**POWER FLOOR PLAN
 NEW WORK - ELECTRICAL**

REV. NO.	DATE	DESCRIPTION
PROJECT MANAGER: MICA 1200 MOUNT ROYAL AVENUE BALTIMORE, MARYLAND TELE: 410-862-7591		
ARCHITECT: ARIUM AE 801 W. HANCOCK ROAD SUITE 300 COLUMBIA, MD 21045 WASHINGTON DC 20142-6400 www.ariumae.com		
PROJECT: MICA ANNEX BLDG THIRD FLOOR 116 W. LANVALE STREET BALTIMORE, MARYLAND		
TITLE	FLOOR PLANS - ELECTRICAL	ISSUE DATE
PROJECT FILE NAME	MIL-25-16	5.20.16
DRAWN BY	SAR	PRL
CHECKED BY	SAR	PRL
DATE	5/20/16	5/20/16
I CERTIFY THAT THESE DOCUMENTS WERE PREPARED OR APPROVED BY ME, AND THAT I AM A LICENSED ENGINEER UNDER THE LAWS OF THE STATE OF MARYLAND. LICENSE NUMBER: 28334 EXP. DATE: 10/2017		
DWG NO.	E-2

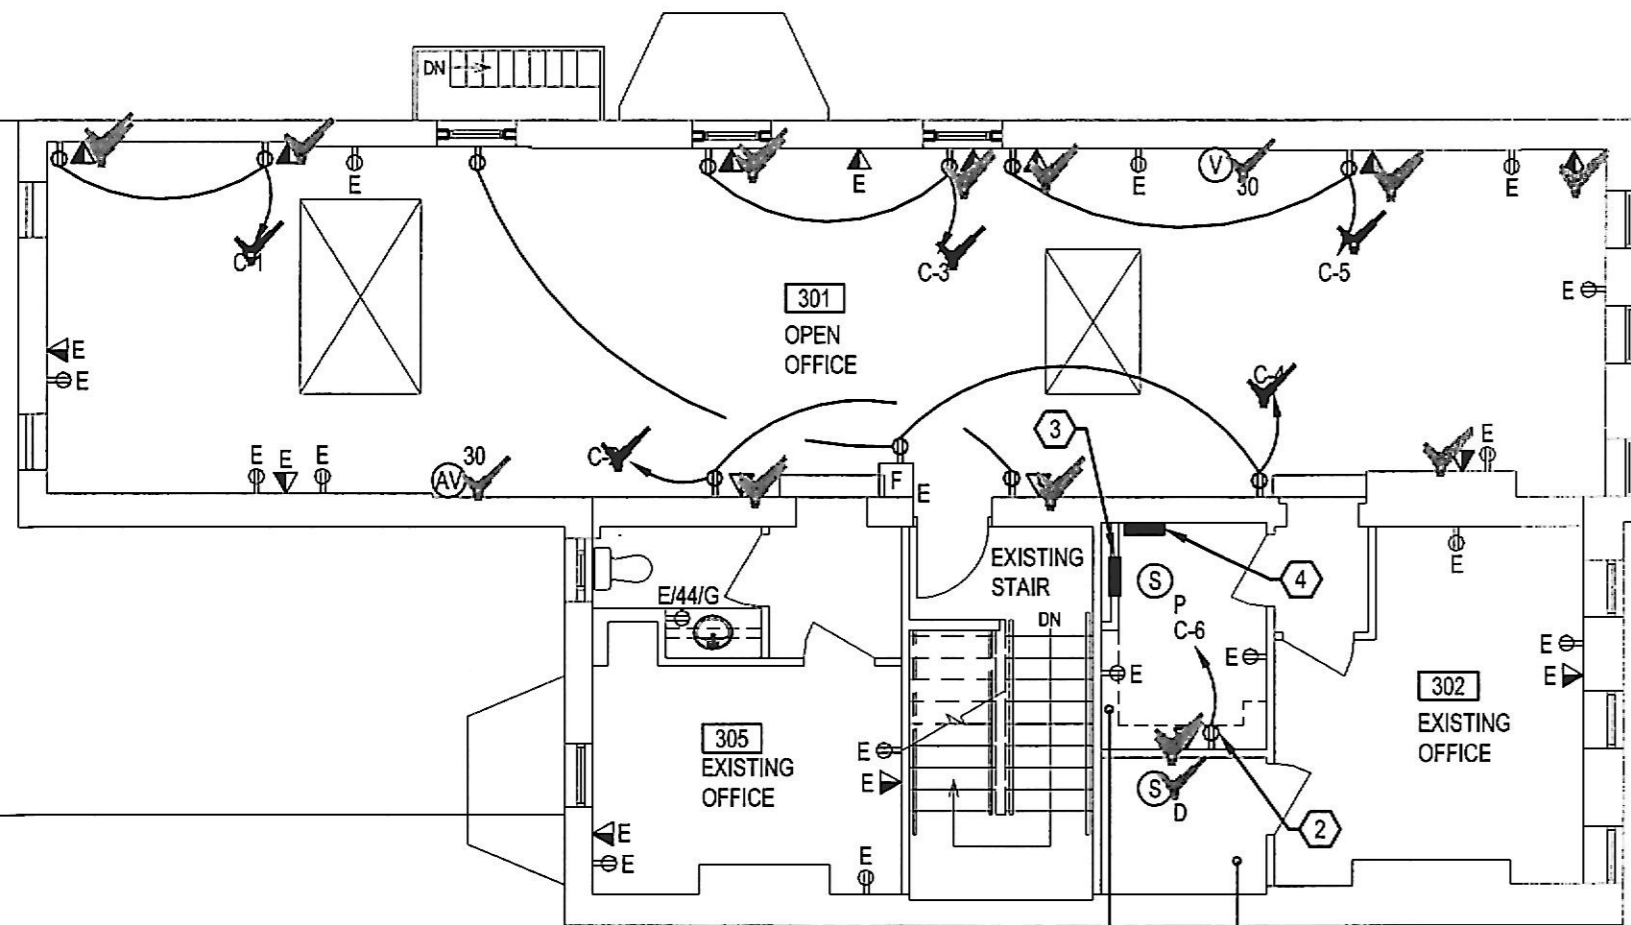
*Perked work each outlet
 4" box w/ metering*
